**Iowa Department of Transportation
Highway Division**

STANDARD DESIGN - 44' ROADWAY, THREE SPAN BRIDGE
**PRETENSIONED PRESTRESSED
CONCRETE BEAM BRIDGES**
MARCH, 2007

SUPERSTRUCTURE DETAILS

H44-03-07

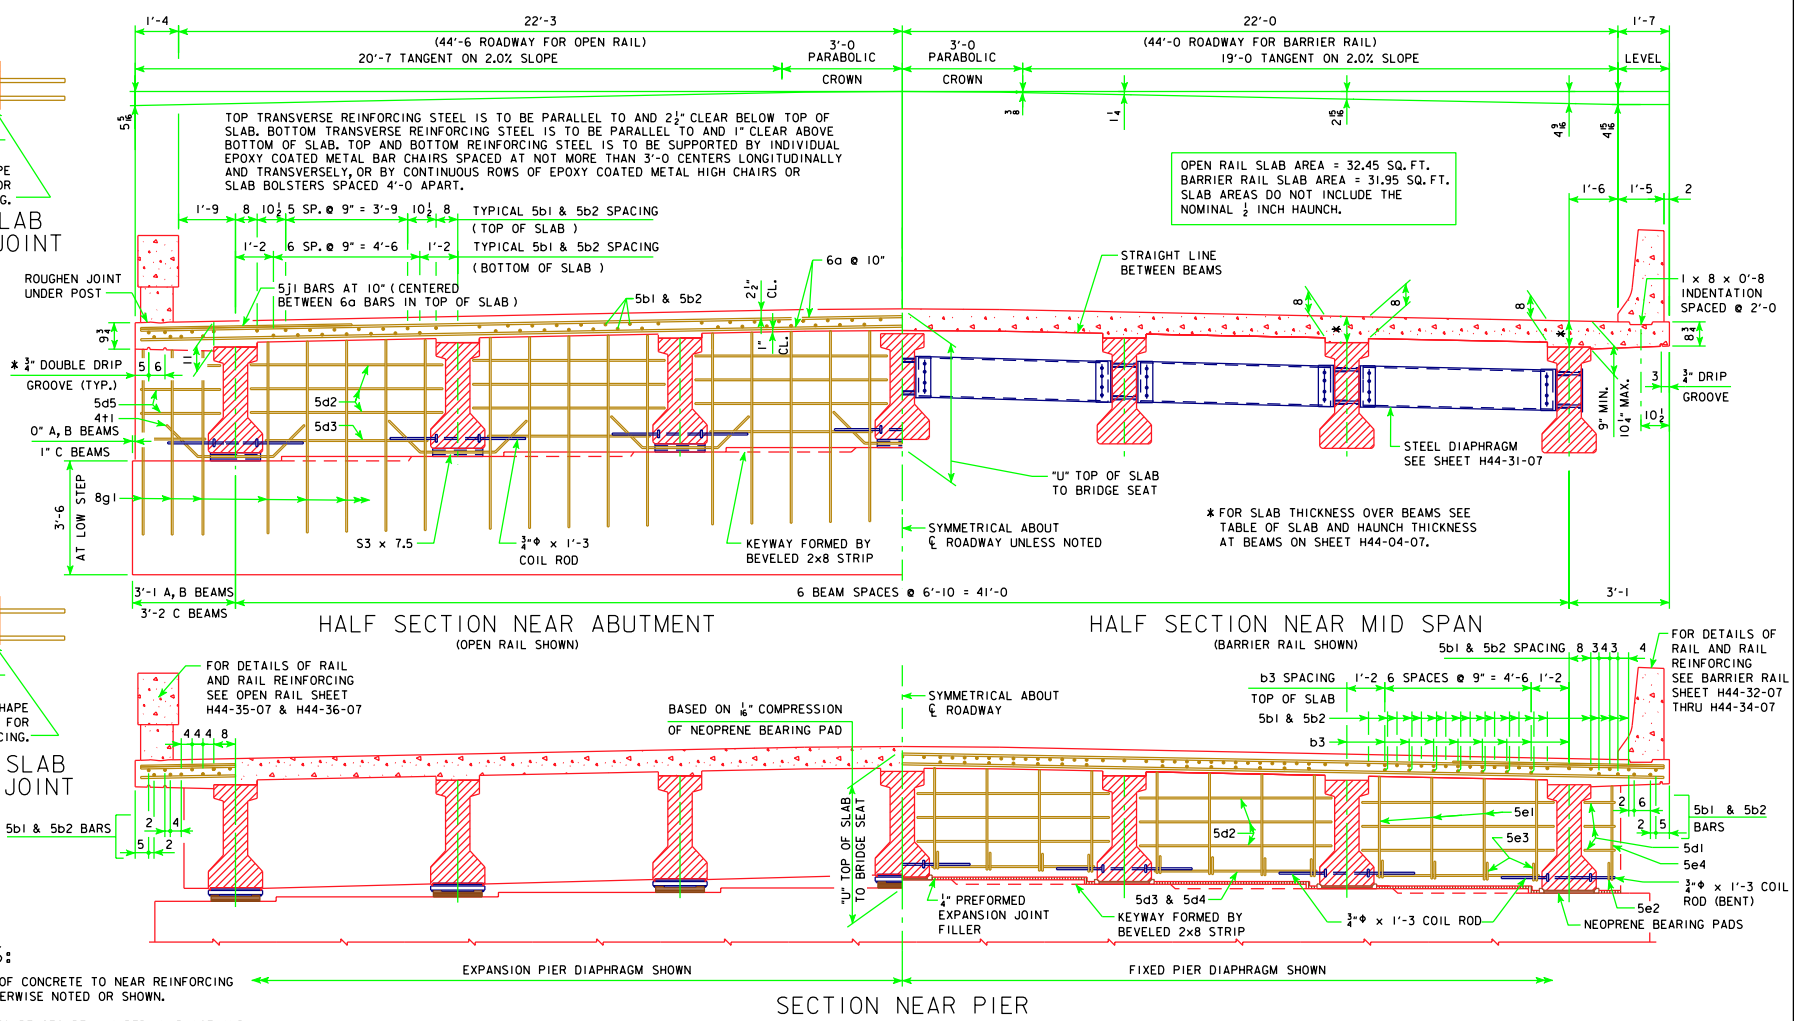
REVISED 11-09 - DOUBLE DRIP GROOVE NOTE WAS ADDED.
